CORRESPONDENCE RELATED TO PLANNED INVESTIGATION AND/OR REMEDIATIONS
AT PLANT 1 AIR COMPRESSOR BUILDINGS 341 AND 252 SOLID WASTE MANAGEMENT
UNITS 37A AND 37X (SWMU 37A) (SWMU 37X) AND SEPTIC TANK SITES WITH
TRANSMITTAL ALLEGANY BALLISTICS LABORATORY ROCKET CENTER WV

Re: Building 341
Allegany Ballistics Laboratory
Rocket Center, Mineral County

SITE CHARACTERIZATION STUDY; BUILDING 341 (COMPRESSOR HOUSE)

Re: Allegany Ballistics Laboratory
Building 341
Rocket Center, Mineral County

SAMPLING LOCATION DIAGRAM

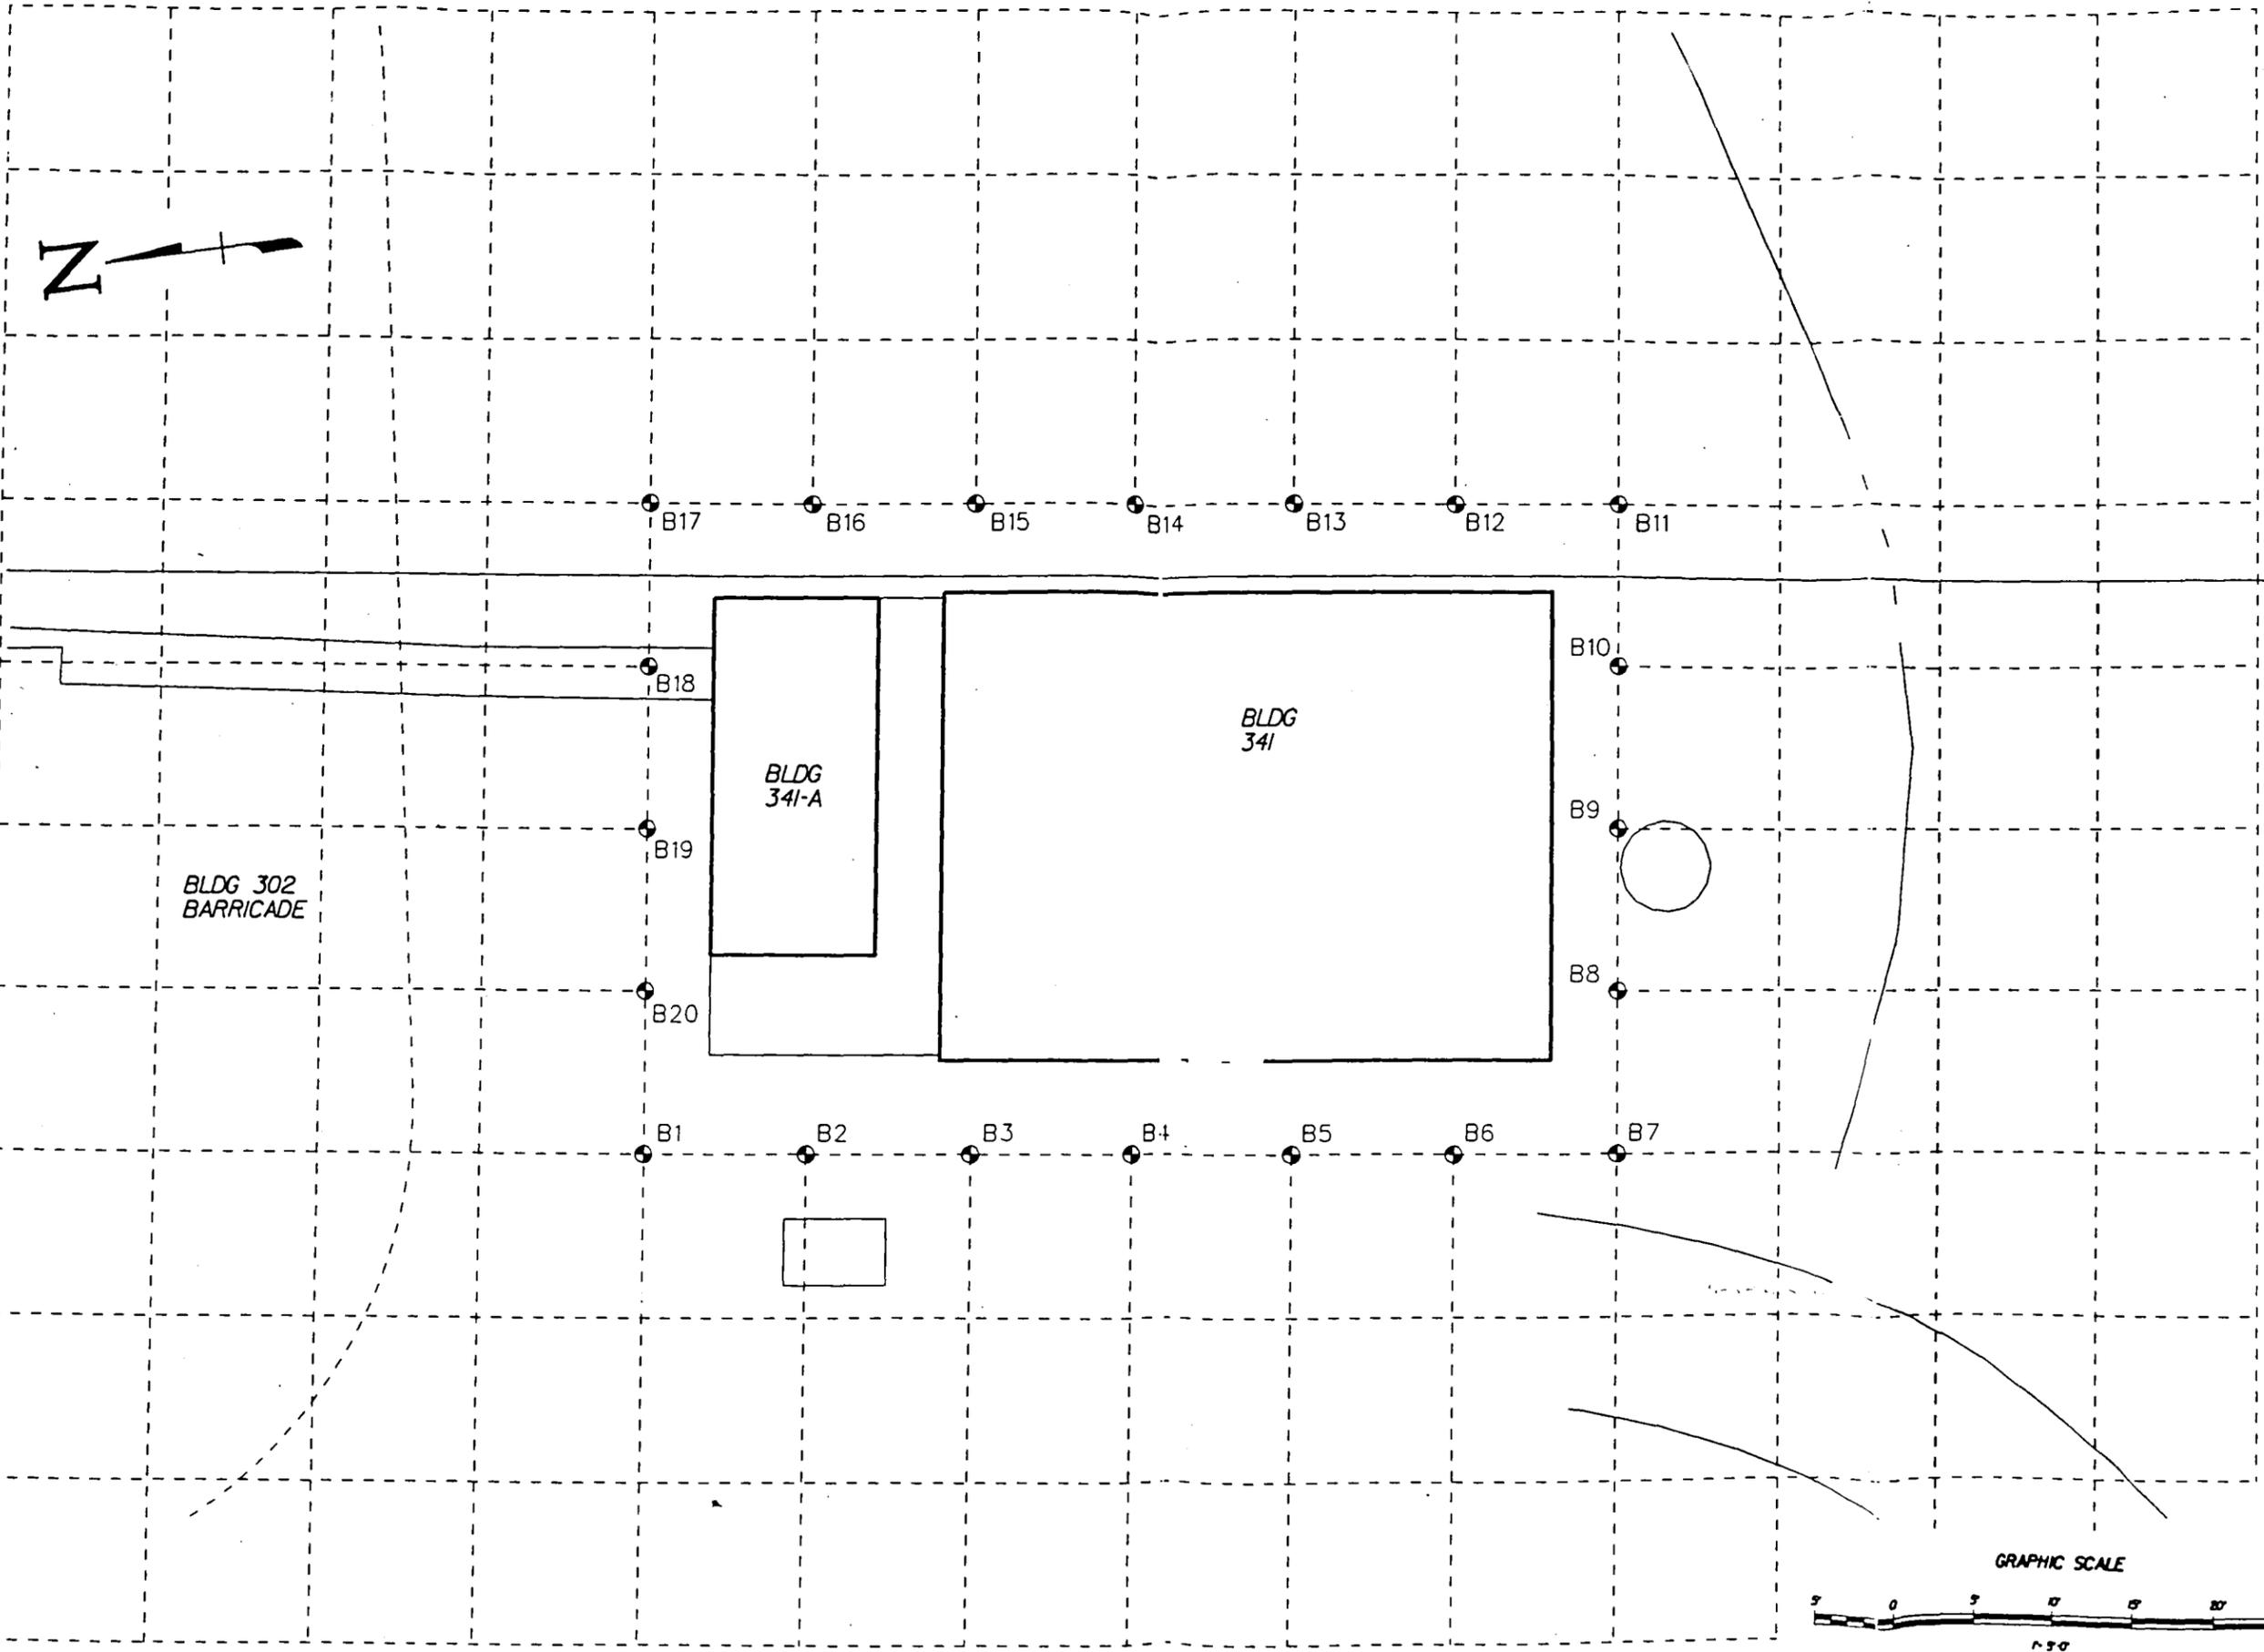
- Complete a subsurface survey to determine the nature and the horizontal and vertical extent of the suspected contamination. Sampling of both the soil and groundwater shall be conducted to ascertain the concentration and phases of any contamination. All subsurface utilities and piping will also be located and investigated as potential contaminant routes.

- Initially a ten by ten foot grid will be established around the Building 341 and 341A pad site. Twenty borings shall be made along the perimeter of the building pad using a Geoprobe. The first set of borings will be made approximately five feet from the edge of the building pad. Where conditions dictate that the boring locations must be moved, an alternative site will be chosen as near to the original site as possible.

Our serious concern is that our office cannot allow you to delineate the extent of the contamination using only a mobile laboratory. The problem, simply put, is that a field laboratory cannot be properly calibrated to give accurate results. Results often indicate there is contamination when there is not, and vice versa. On the other hand, we realize that you will need to obtain the results immediately if your plan to delineate the contamination in one mobilization is to be achieved, and we can offer two suggestions.

The first option is to locate beforehand the services of a nearby permanent West Virginia certified laboratory, rush the samples to this laboratory, and obtain a fast turnaround. The samples from the first geoprobe samples can be analyzed at this laboratory while the geoprobe is collecting its subsequent samples. The additional geoprobe sampling (after the first 20 samples) can then be based on the results of the permanent laboratory's analytical results.

The second option is to use the mobile laboratory to locate the contamination in the field, and then confirm the results using a permanent West Virginia certified laboratory. This will allow you to have the fast turn around in the field, but also the more analytical dependable samples from the permanent laboratory.
